Re: Immediate Response Action (IRA) Plan Modification No. 4
Former Barnstable County Municipal Fire Training Facility
155 South Flint Rock Road
Barnstable, Massachusetts 02601
Release Tracking Number (RTN) 4-26179

**IRA PLAN MODIFICATION
 SITE PLAN**

APPENDIX D – PUBLIC INVOLVEMENT PLAN COMMENTS AND RESPONSES

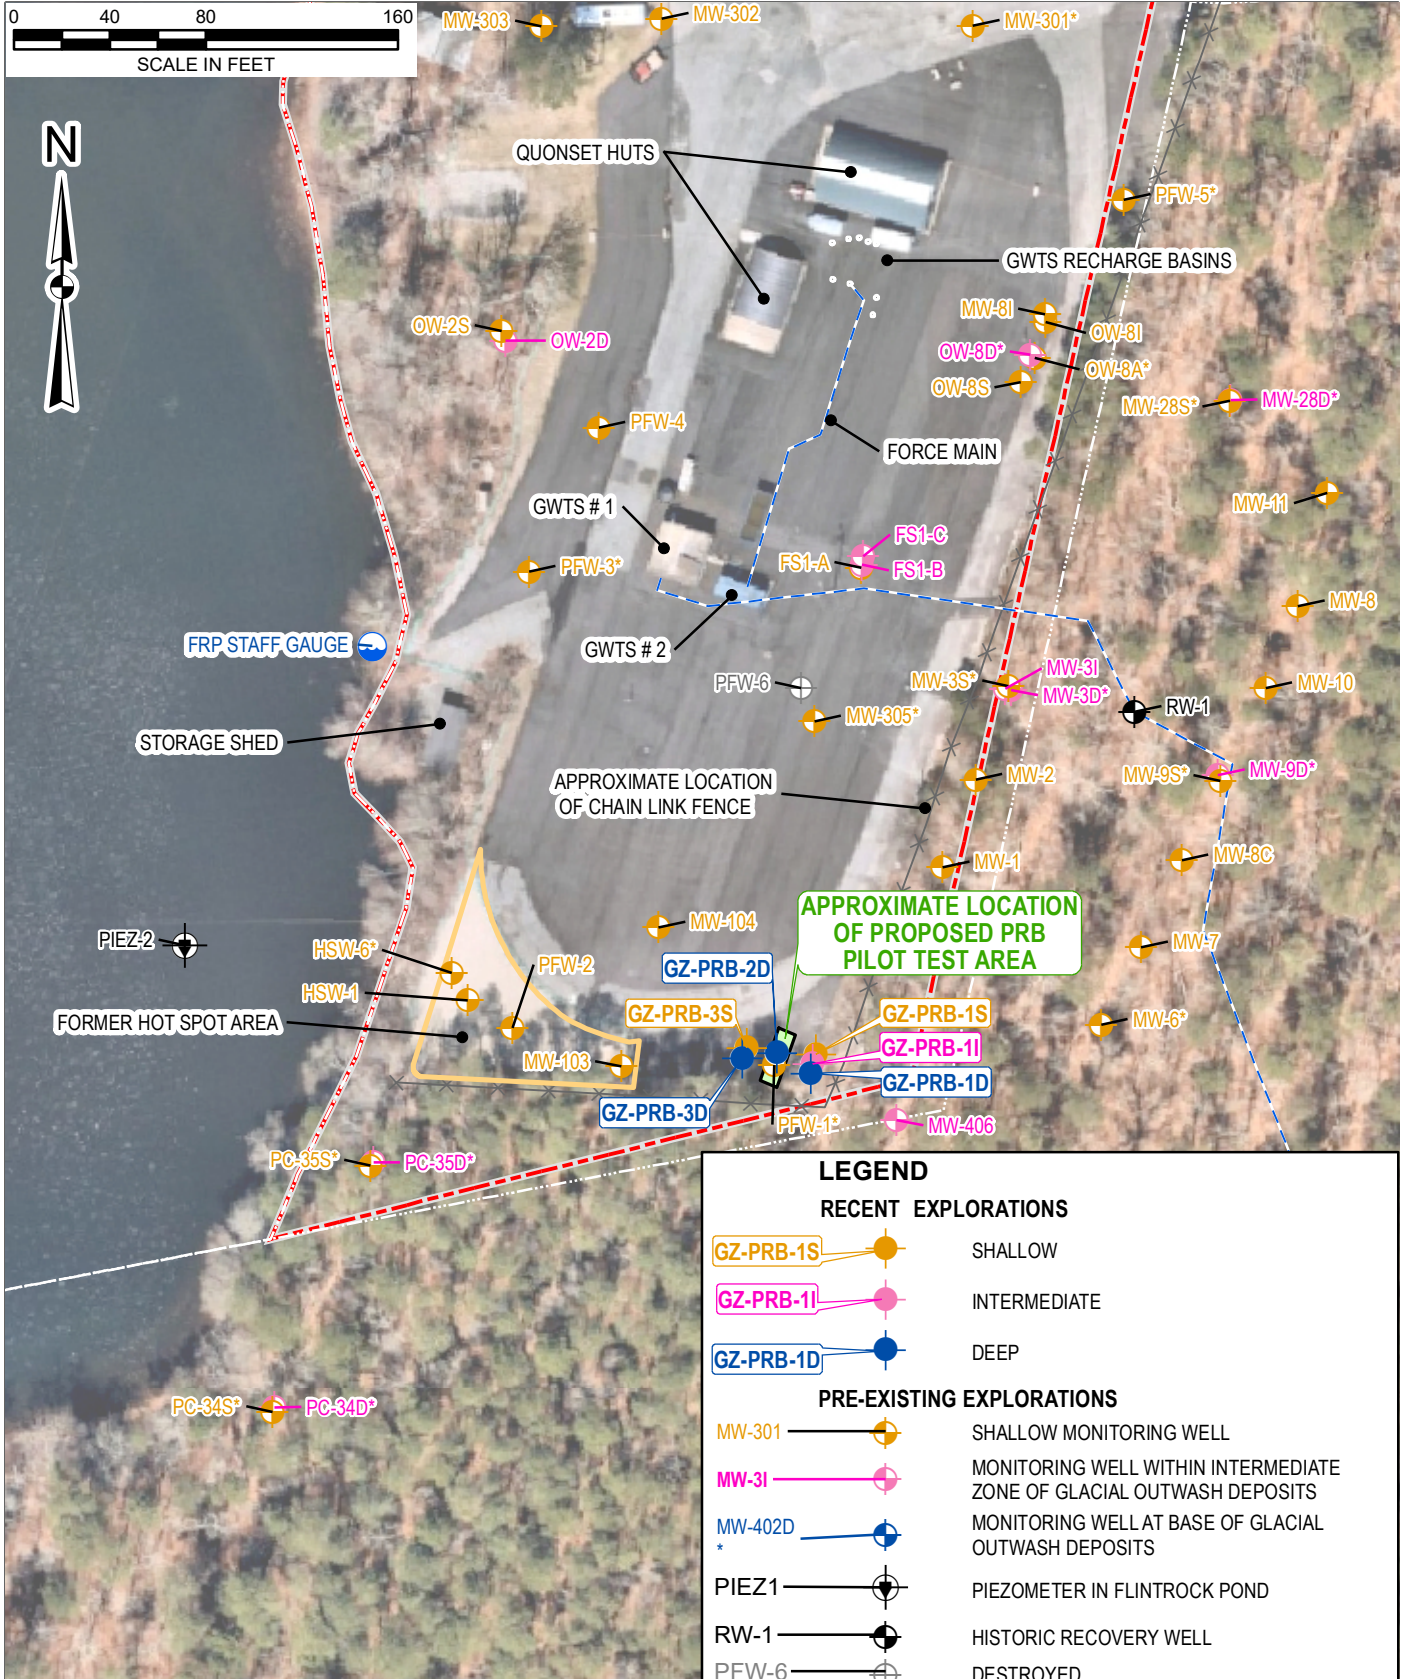
Comment Code	Entity or Individual
Cambareri	Thomas Cambareri, 62 Joan Road, Centerville, MA 02632
Comments Received on Draft IRA Plan Modification as of July 9, 2024	
Cambareri-1	<p>Comment: Although the intended PRB configuration appears as if it will contain further releases from upgradient, it is prudent to continue to monitor PFAS in the PFW-2 source area.</p> <p>Response: GZA plans to monitor PFAS levels in the source area near PFW-2. Monitoring results will be provided in a future status report for RTN 4-26179. In addition, GZA notes the proposed pilot study is limited in area and designed to assess the efficacy of a PRB prior to full-scale implementation. We anticipate that full-scale implementation would involve a significantly longer PRB and/or multiple PRBs. If the pilot test is successful as expected, full-scale implementation would be conducted under a separate IRA Plan Modification.</p>
